Bid 652
Gym Bleacher Replacement Project for Channel Islands and Hueneme High Schools

BID CLARIFICATION ADDENDUM #1

Dated: November 02nd, 2021

7 DETAIL

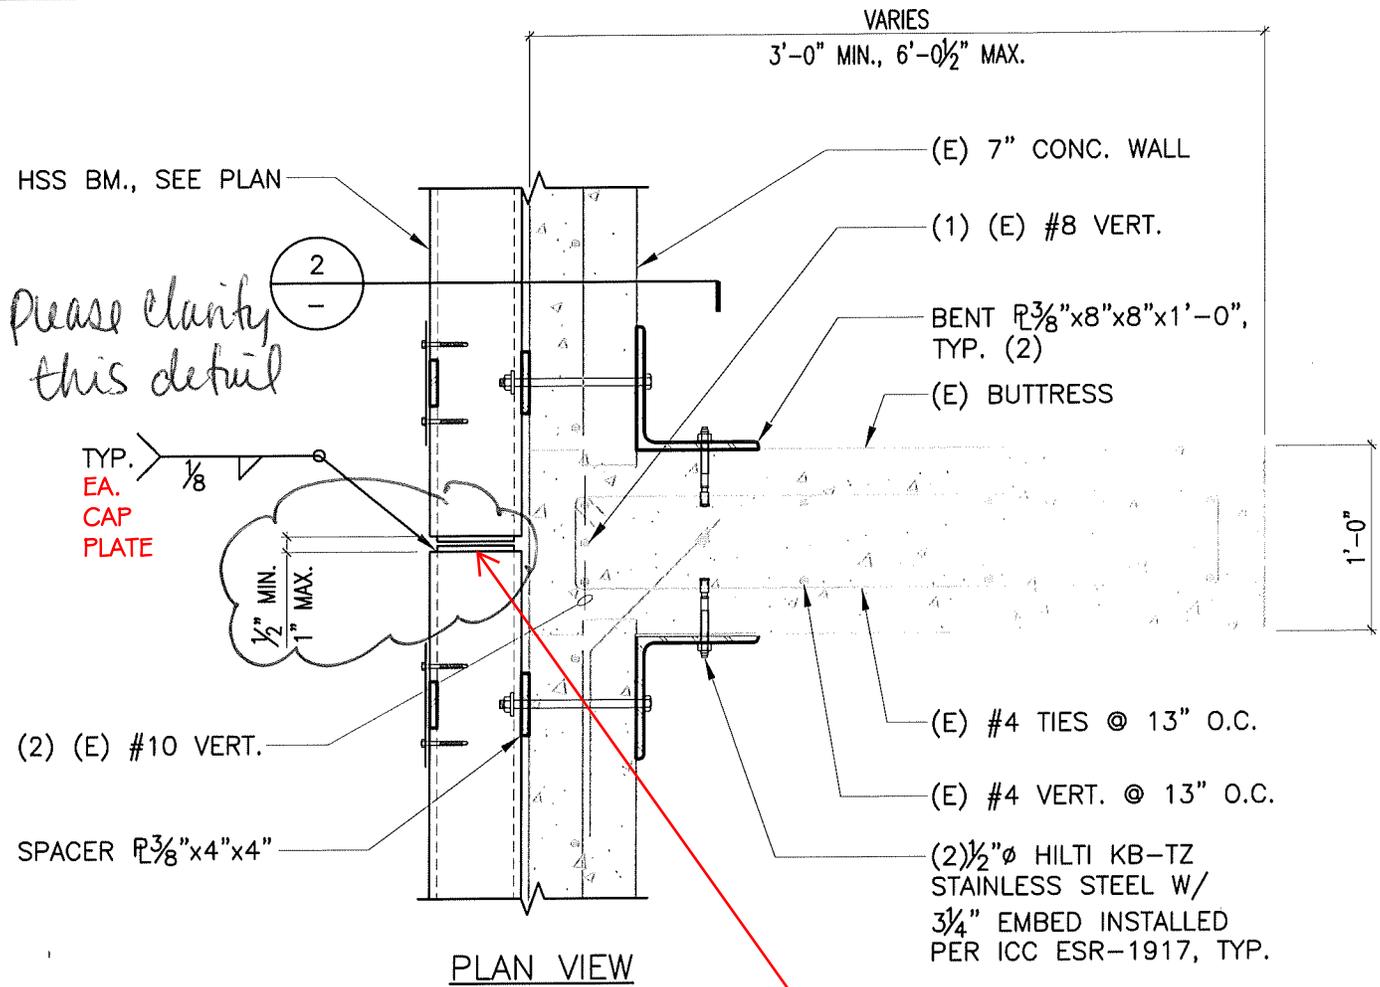
Question from Ardalan Construction: Can you please provide clarifications to the detail attached. The sleeve appears to be inside the HSS, but it is not clear.

please clarify this detail

Note: The above markup in red colored font was provided by Architect/Engineer.
